AMENDMENT NO. 1 NOVEMBER 1984

IS : 9484-1980 SPECIFICATION FOR CENTRE BOLTS FOR LEAF SPRINGS

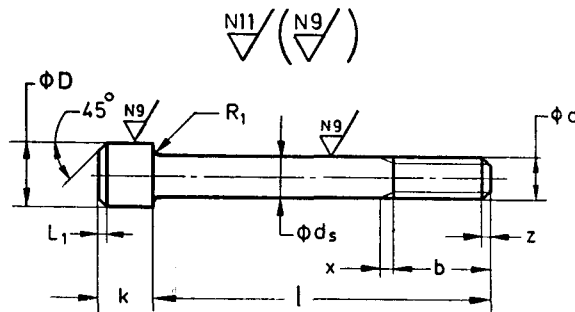
(Page 1, clause 2) — Substitute the following figure for the existing figure ' Leaf Spring Bolt ':
